# System Impact Assessment Report

**Project:** Fort Chicago London District Energy  
Cogeneration Plant

**CAA ID 2007-261**

June 27, 2008

**Figure 3: Standard for Setting Under-Frequency Trip Protection for New Generators**

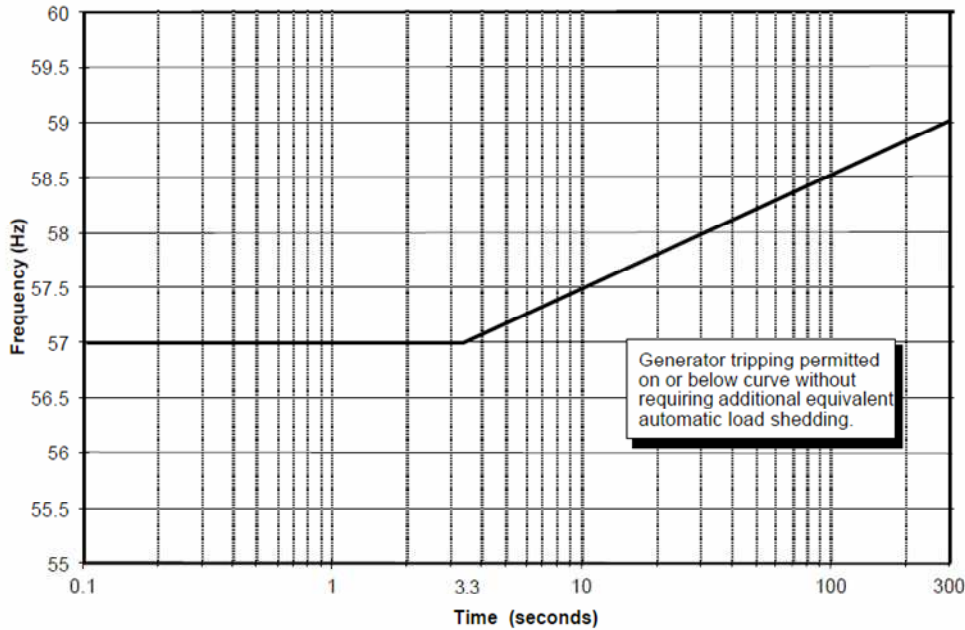
4. The synchronous generator should be capable of operating at full active power for a limited period of time for grid frequencies as low as 58.8 Hz. The synchronous generator should not trip for under-frequency system conditions that are below 60 Hz but above 57.0 Hz and above the curve shown in Figure 3 of this report.

Reference #3 of Appendix 4.2 of the *Market Rules* requires generating facilities to be capable of operating continuously at full power for a system frequency range between 59.4 to 60.6 Hz. For under-frequency system conditions, generators shall not trip for frequency variations that are above the curve shown in Figure 3.

The Proponent confirmed that the plant will satisfy the standard from Figure 3.

**Figure 11: GT1 Exciter Response Ratio Test**

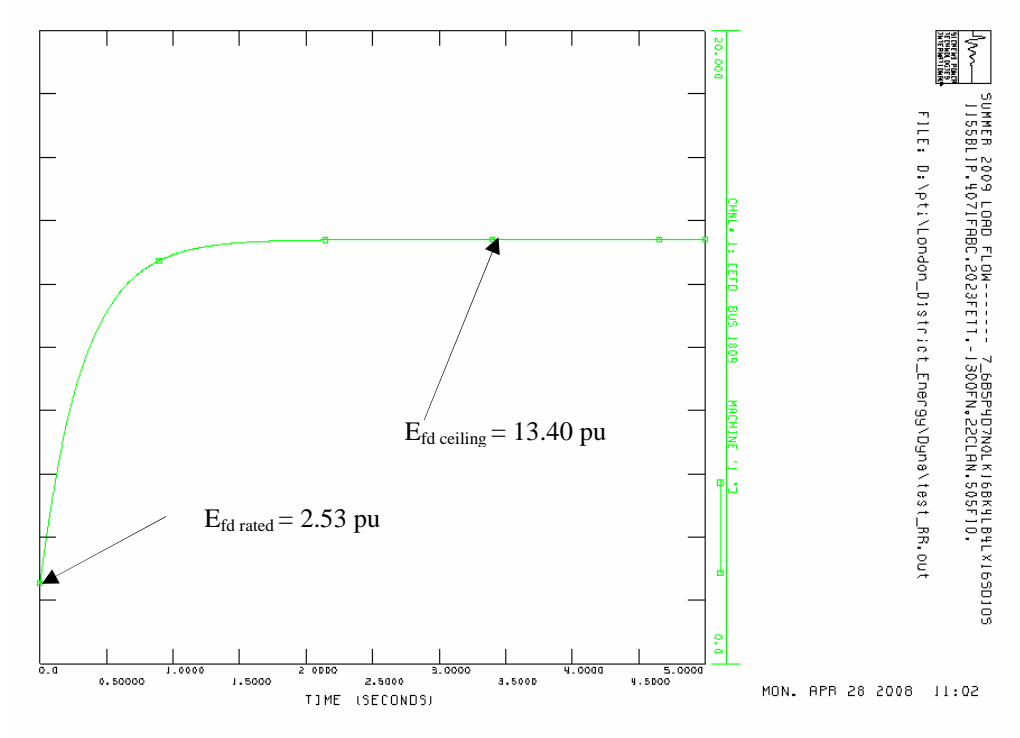
It can be observed that the GT1 field voltage increased from the rated value of 2.53 pu to a ceiling of 13.40 pu, exceeding the positive ceiling voltage requirement.

**Figure 12: GT1 Exciter Open Circuit Test**

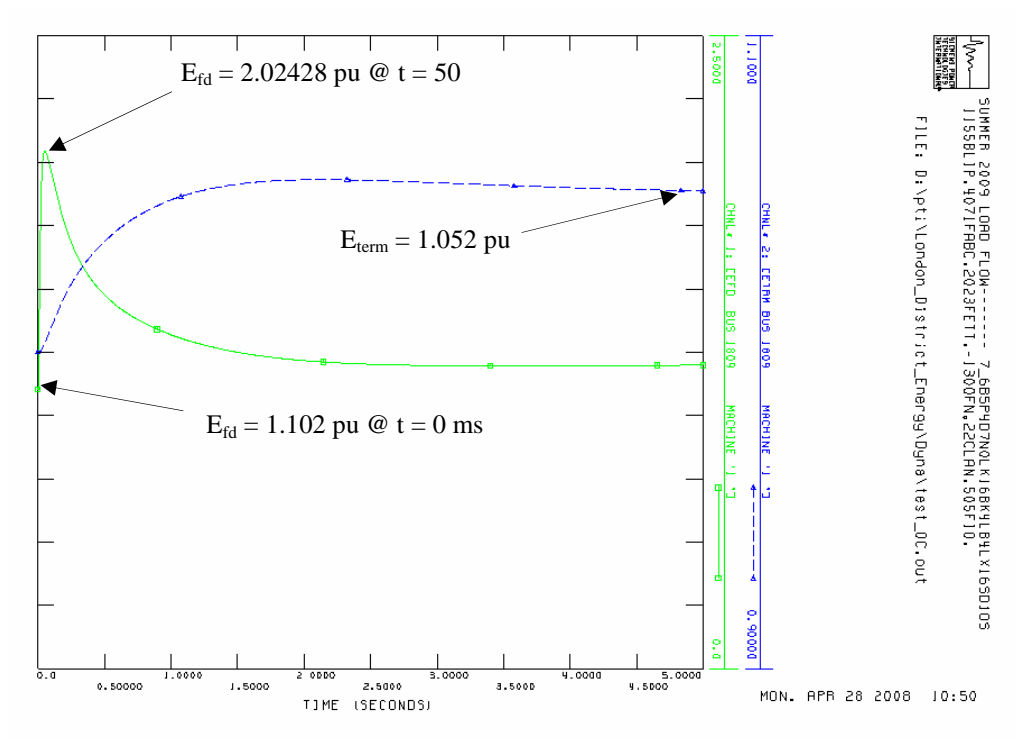
The numerical results from the open circuit test are presented in Table 20 below. It can be observed that the exciter does not meet the field voltage response time requirement, as per higher standard requirements from Appendix 4.2 of the Market Rules.

**Figure 13: GT1 Exciter– Nominal Response Calculation**

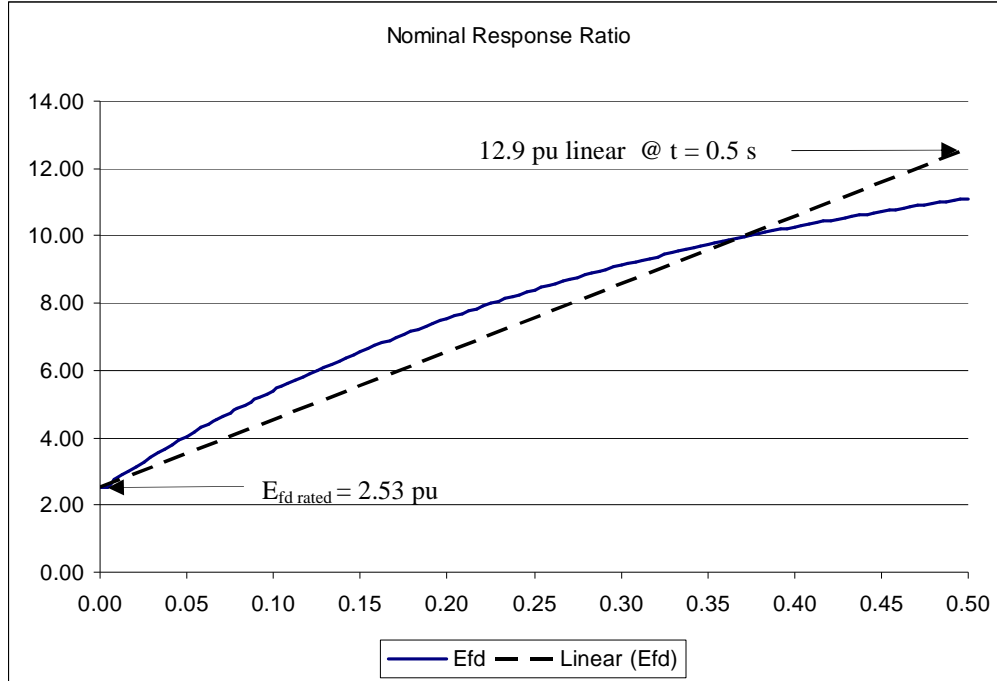
To assess the excitation system compliance with the lower performance requirements, the nominal response was calculated using the Response Ratio test for 0.5 seconds, as per Figure 13. The calculated nominal response was 8.20, exceeding the minimum nominal response requirement of 0.5.

$$\text{Nominal Response} = (12.9 - 2.53) / (0.5 \times 2.53) = 8.20$$

Figure 14: GT1 Governor Test

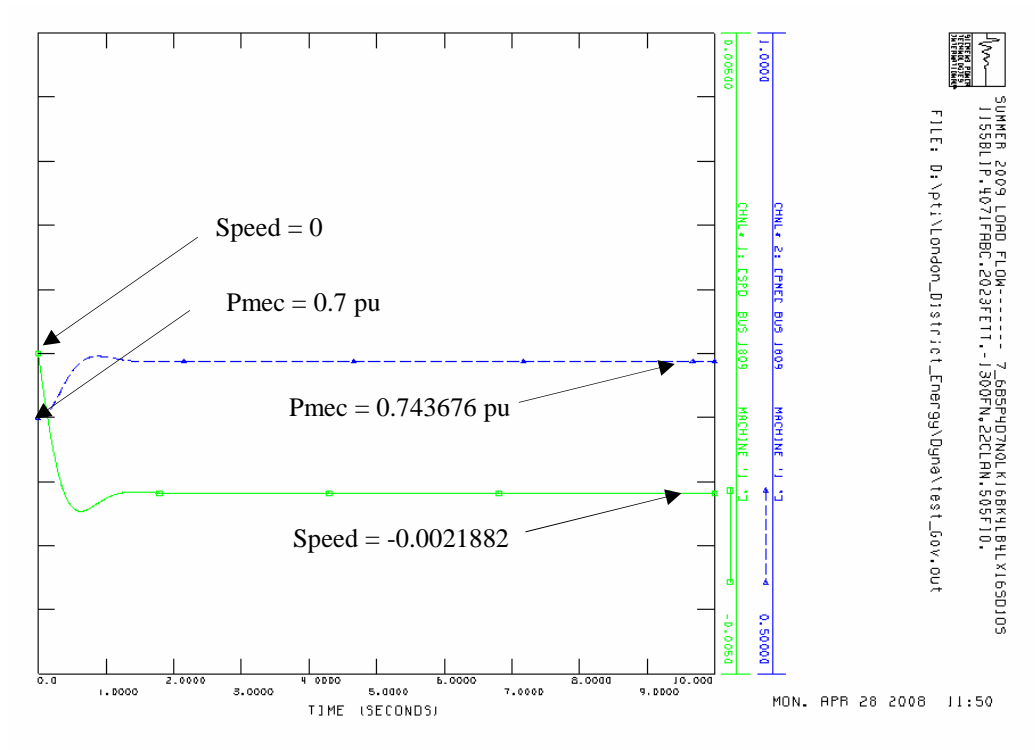
As can be observed, the governing unit presented a well damped response. The calculated resulting droop was approximately 5%. No intentional frequency dead band is added to the proposed governor model.

Figure 20: Voltages – W37 fault – Peak Load (2 sec)

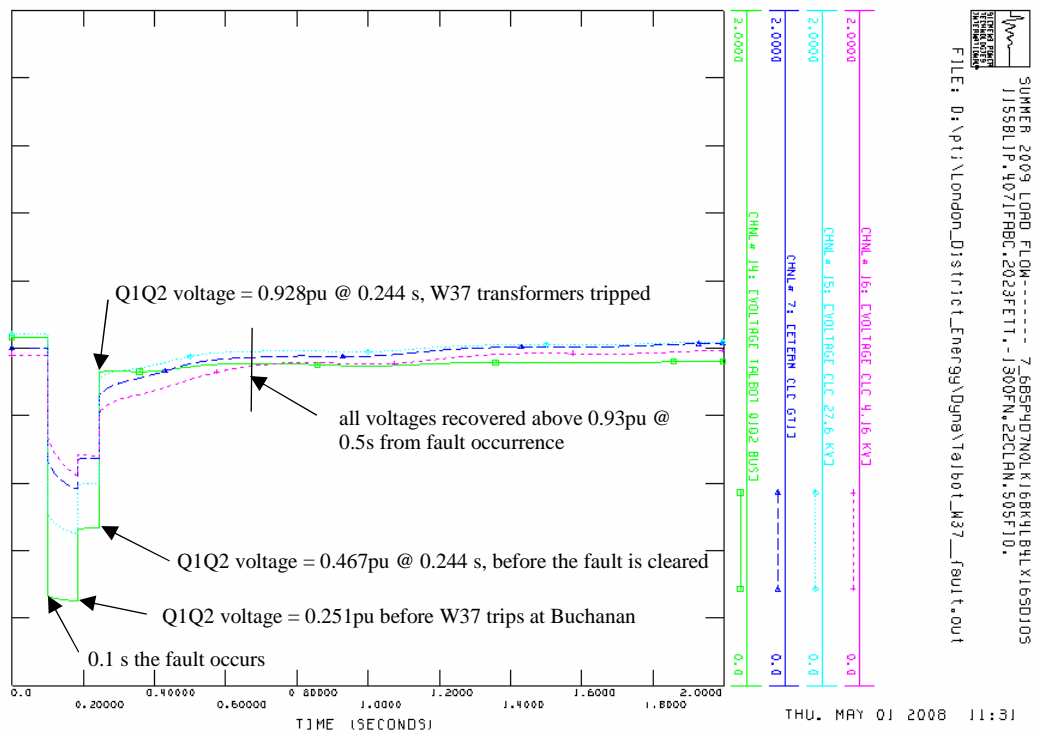
From Figure 20 above, it can be seen that during the fault on the circuit W37, the voltage on the LV bus Q1Q2 went as low as 0.251 pu for 83 ms, but recovered after 144 ms to 0.928 pu when the fault was cleared. The voltage performance at the Plant connection point is presented for information purposes only. It is the Proponent's responsibility to ensure that the Plant meets the low voltage ride through requirement.

The Plant shall not trip for recognized contingencies on the transmission system unless the contingency would disconnect the generating unit by configuration. All embedded generators shall have sufficient low-voltage-ride-through capability to avoid generation loss for faults in the transmission system.
